DOCUMENT 00 9113

ADDENDA

CITY OF BERKELEY

BERKELEY MARINA SELECTIVE TIMBER PILE REPLACEMENT

Sheet Reference No.
C-005

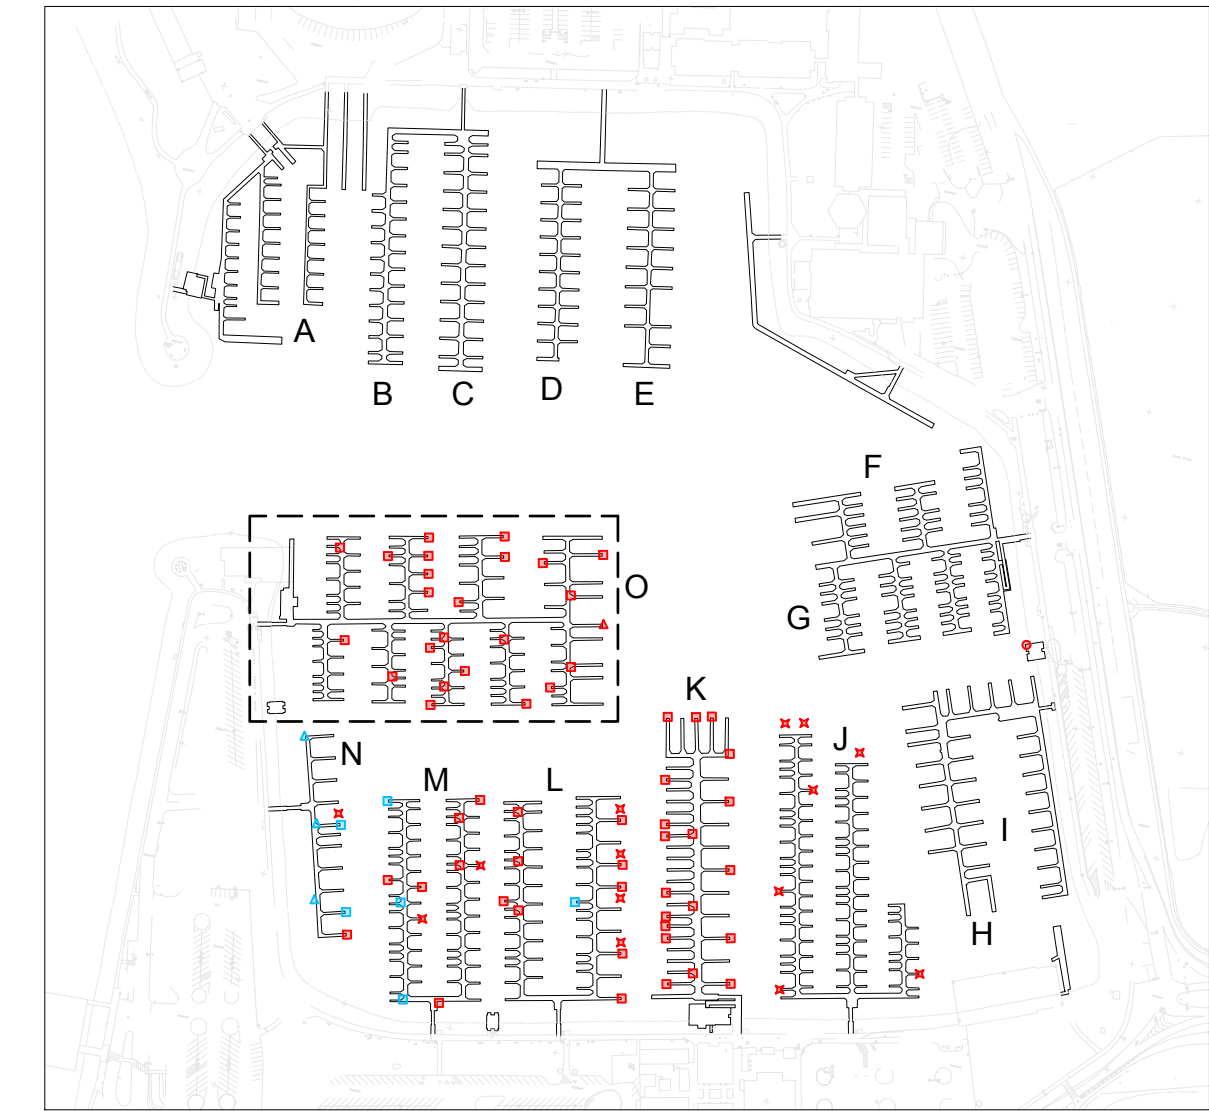
1. Sheets G-002, C-005: Revise two piles for replacement on O Dock.
2. Sheet C-006: Prestressing values in Note 3.3 have been revised
Note 7 includes additional information on the polymer cover
Prestressed strands were modified in Detail B
Details 4 and 5 were added for methods of pile guide installation at deteriorated docks

Mark	Description	Date	Appr
A	ADJUST PILES TO REPLACE	2/14/2023	BP

Sheet Reference No.
C-006
INDEX: 8 OF 9

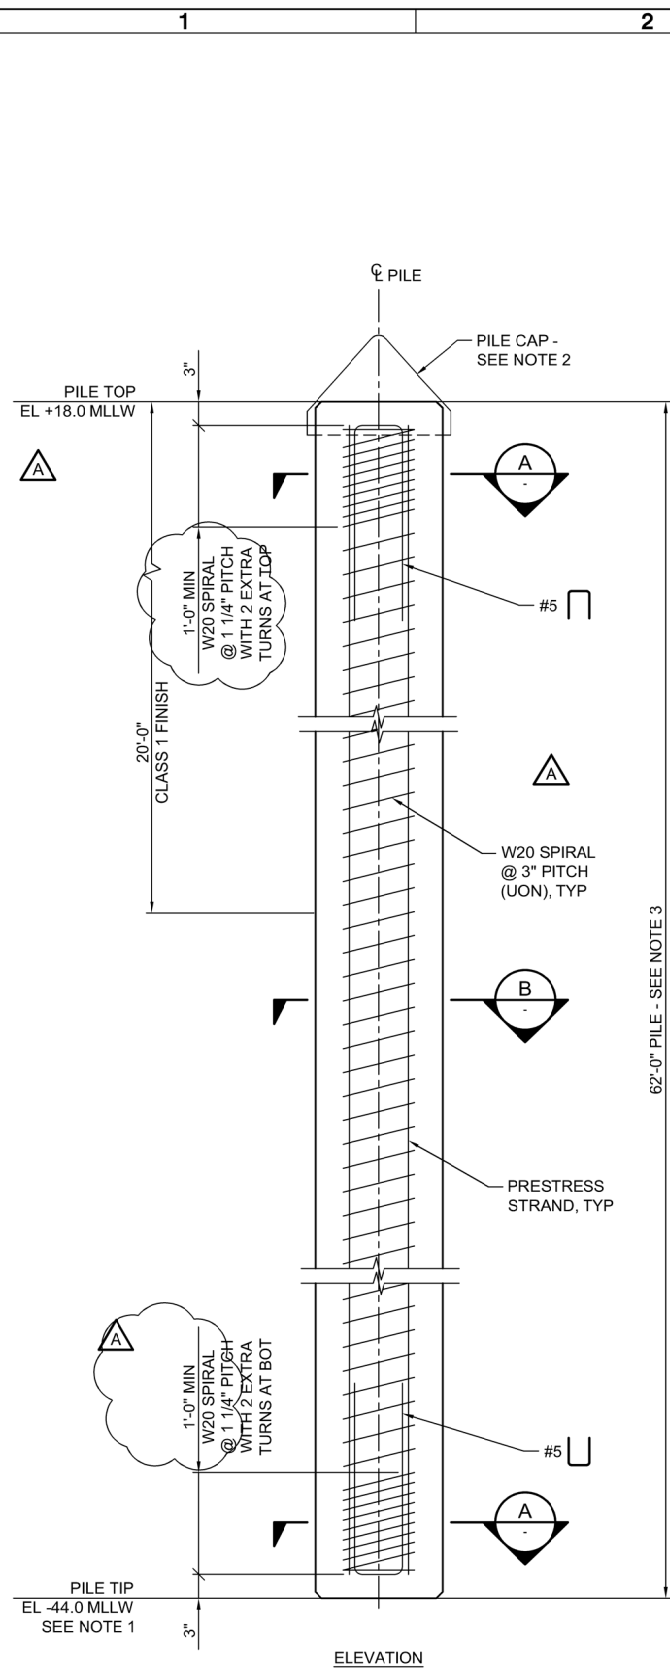
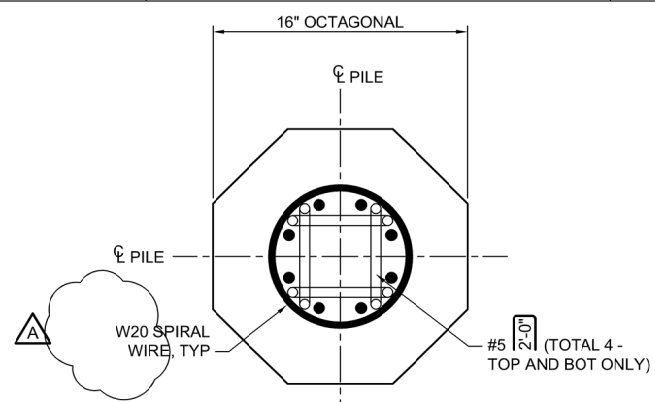
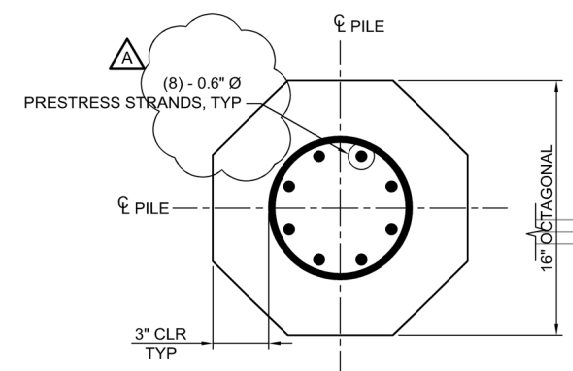
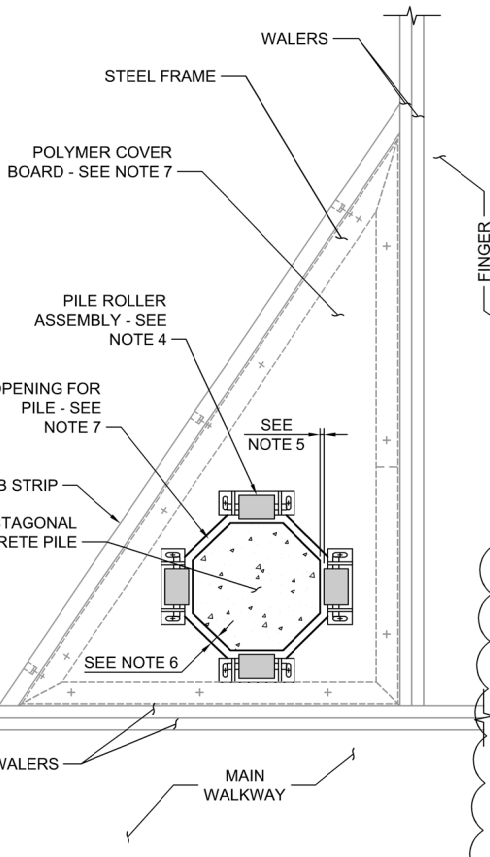
Q20: Per Note 3.3 of Drawing C-006, the piles are specified to an effective prestress of 2,070 psi., with the calculated prestress loss given as 63.7 ksi, the working force per strands as 48.2 kips and the jacking force of 385.8 kips.

- a. Please assist to reconcile the numbers and working force.
- b. Most marina piles effective prestress is around the vicinity of 1,000 psi. Specifying an uncommon effective prestress of 2,070 psi adds too much prestress, making the pile difficult to fabricate and thus increasing cost drastically. Please consider lowering the prestress to 1,000 psi range.

Q21: Most San Francisco Bay Area marina piles use 0.5" or 0.6" strands. However, this project call for a larger 0.7" strands, this will drive up the cost of the pile, please reconsider the use of 0.5" or 0.6" strands.

A20: Prestressing values have been revised on Sheet C-006

A21: Strands have been revised on Sheet C-006.

- PRESTRESSING:
JACKING FORCE PER STRAND SHALL BE 64% OF ULTIMATE
CALCULATED LOSSES = 31.6 KSI
WORKING FORCE PER STRAND = 30.6 KIPS
JACKING FORCE = 300 KIPS
FINAL EFFECTIVE PRESTRESS IN CONCRETE AFTER ALL LOSSES = 1154 PSI

3 EXTERIOR PILE GUIDE DETAIL-TYPE 1
SCALE: 1" = 1'

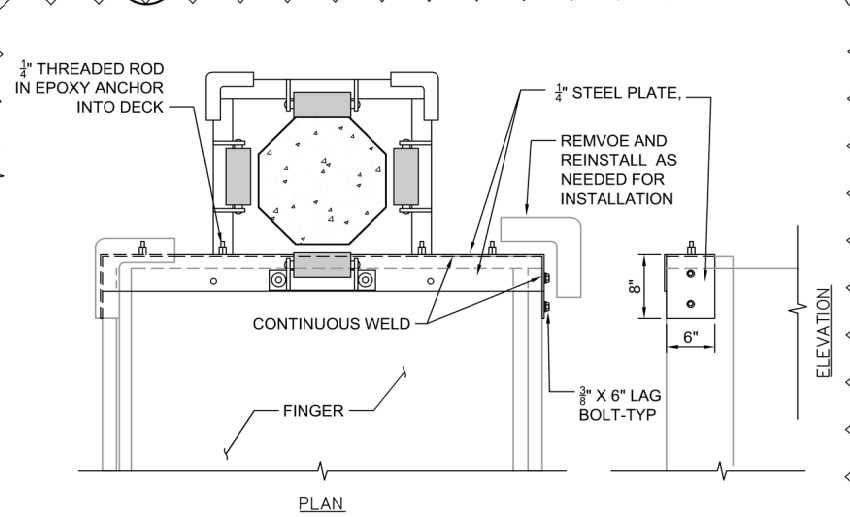
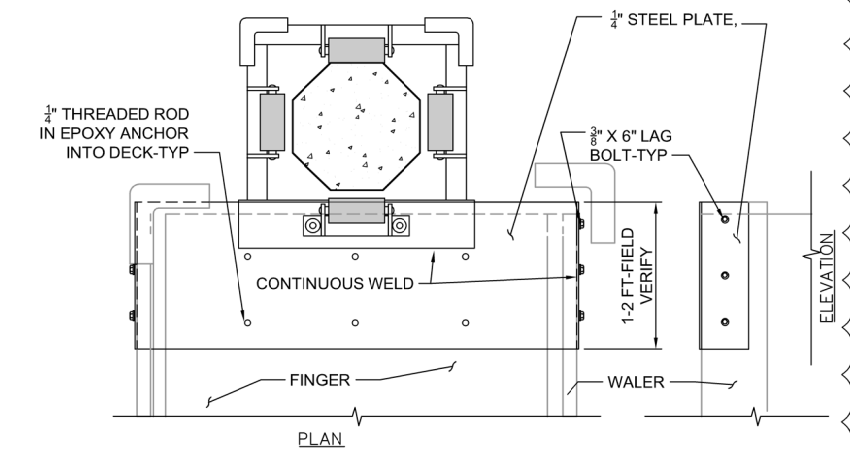
Q14: Sheet C-006 Detail 3 provides detail for exterior pile guides to be installed. Please provide details of the extent of repair if needed due to damaged finger.

A14: Details 4 and 5 have been added to Sheet C-006 to show other installation methods for deteriorated finger ends. Two additional items have been added to the bid table to capture the alternative methods.

A 4 EXTERIOR PILE GUIDE DETAIL-TYPE 2
SCALE: 1" = 1'

A 5 EXTERIOR PILE GUIDE DETAIL-TYPE 3
SCALE: 1" = 1'

9. TYPE 1 PILE GUIDE SHALL BE USED AT ALL LOCATIONS WITH SOLID FINGER MATERIAL. TYPE 2 SHALL BE USED AT FINGERS WITH DETERIORATED FINGER ENDS (12 LOCATIONS), TYPE 3 SHALL BE USED AT FINGERS WHOSE ENDS HAVE BROKEN OFF CONCRETE (3 LOCATIONS). FIELD VERIFY LOCATIONS FOR EACH TYPE.
